**Re: Nob Hill Condos, 110 Richmond Ave SE,
Certificate of Occupancy – Transportation Development
Engineer's Stamp dated 08-06-07 (K16-D071)
Certification dated 05-14-09**

**Re: Nob Hill Condos, 110 Richmond SE,
(K-16/D071)
Approval of Permanent Certificate of Occupancy,
Engineer's Stamp Dated: 12-19-07
Engineer's Certification Date: 5-19-09**

**RE: Drainage Plan for Nob Hill Condos,
K16/D71**

110 Richmond East Alley Plan: Plan 01 7/7/2008

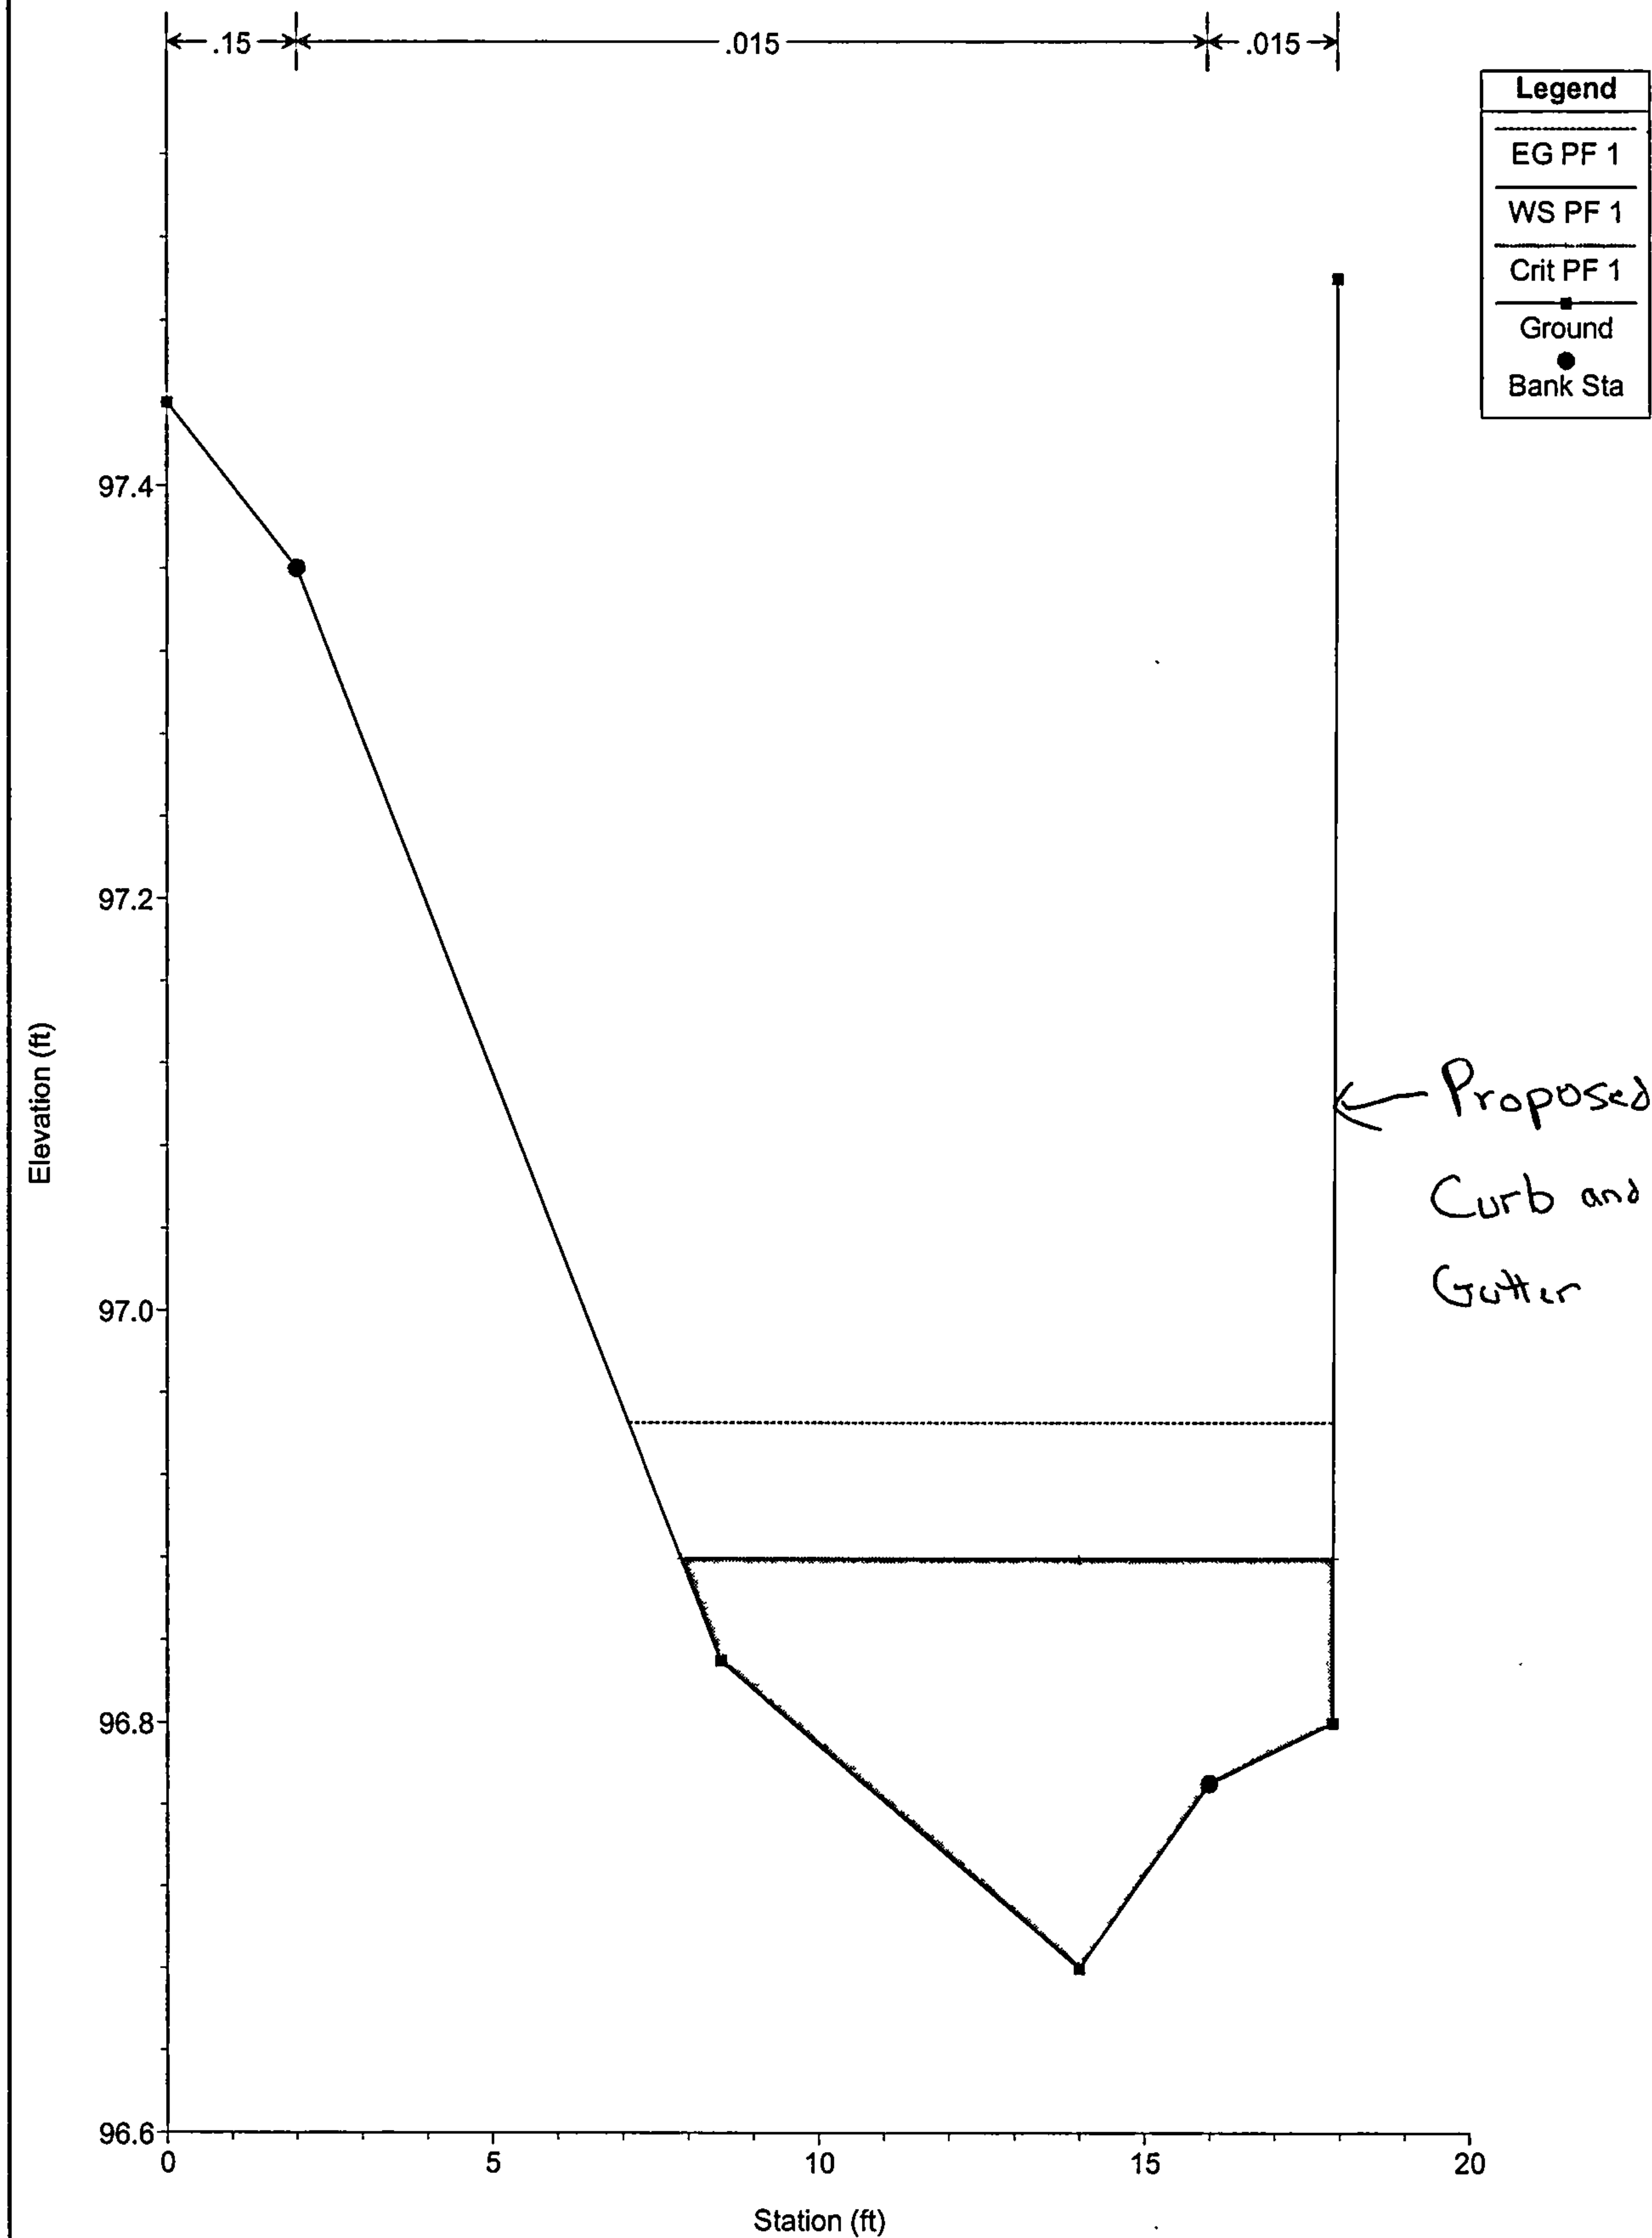
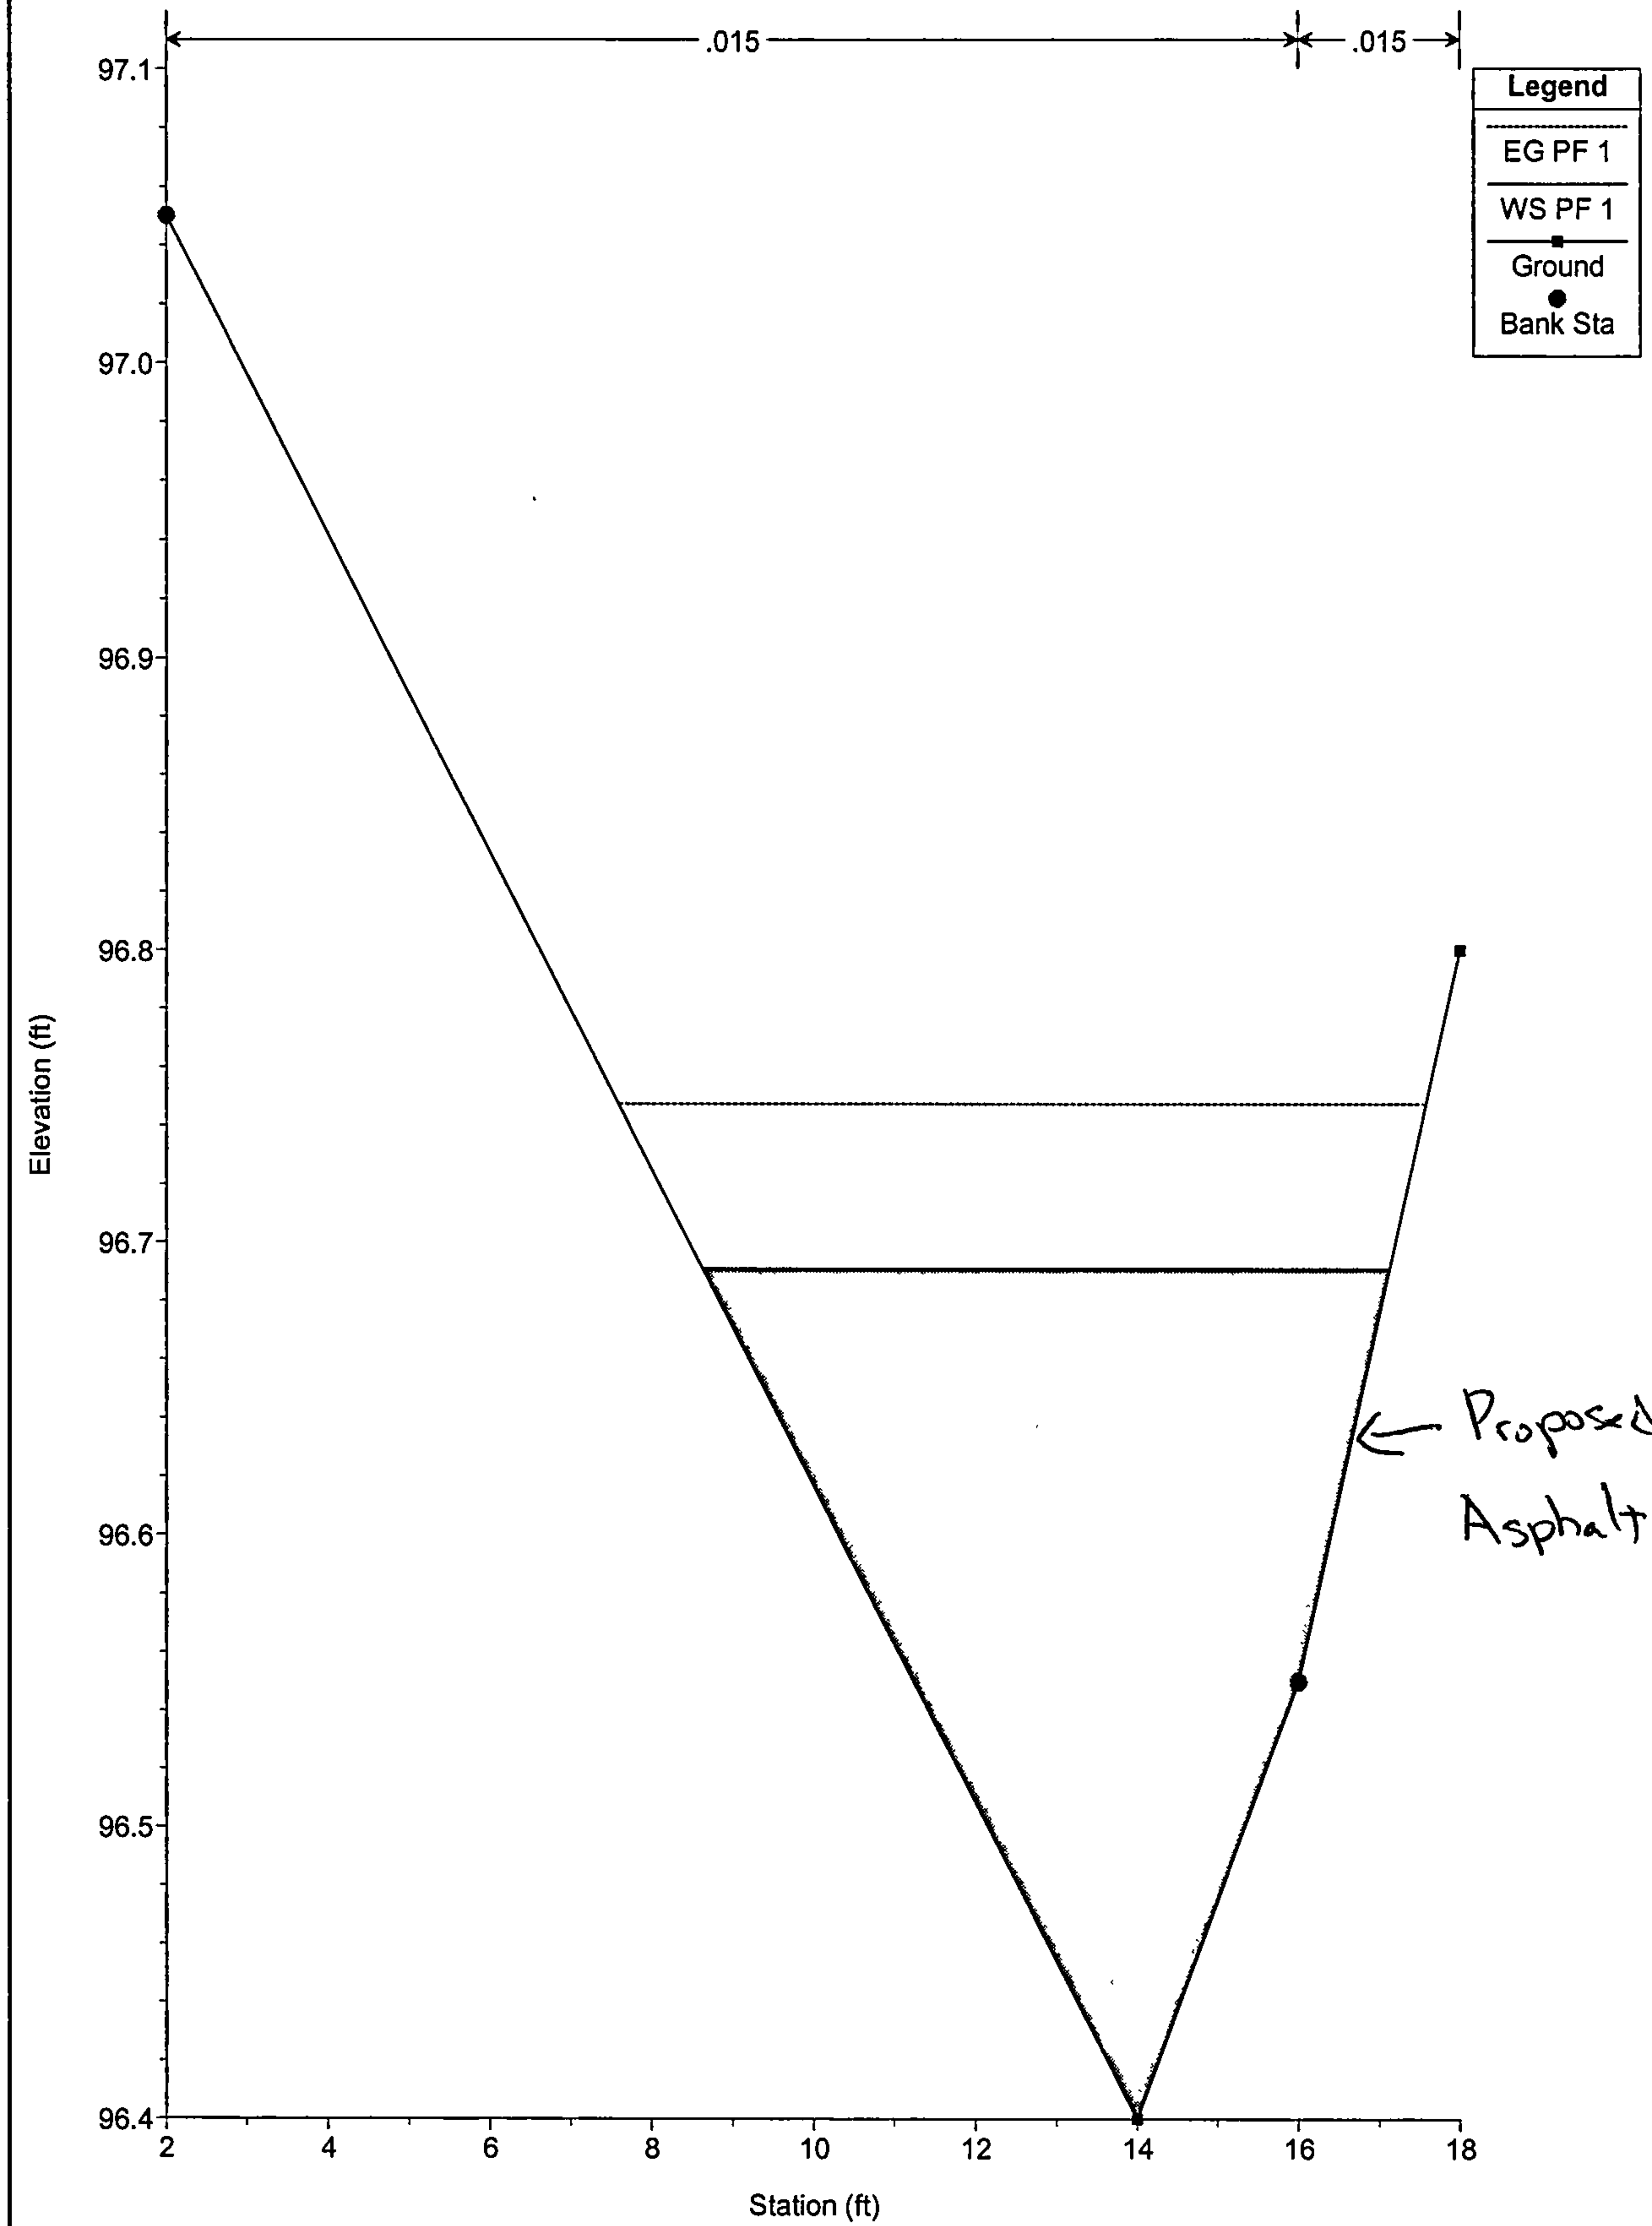
From our meeting it was decided that a couple of addition HEC-RAS sections (03 & 04, see attached) were needed about 75 feet south of the southeast corner of the subject site, behind Lot 7A, University Heights Addition (existing day care business). The attached plan is a modified version of one of the previously submitted grading and drainage plan sheets.

As suspected, our work shows that an additional 3" of paving is needed along the back of Lot 7A adjacent to the alley in order to keep flow contained within the alley during the 6-hour, 100-year storm. Our DRC Work Order Plans have been modified accordingly show this proposed work.

The additional HEC-RAS sections show we do indeed need to add a 3-inch paving section in order to contain 100-year flows in the alley and not let them escape west into the adjoining day care business. Of course typical nuisance flows should not be a problem.
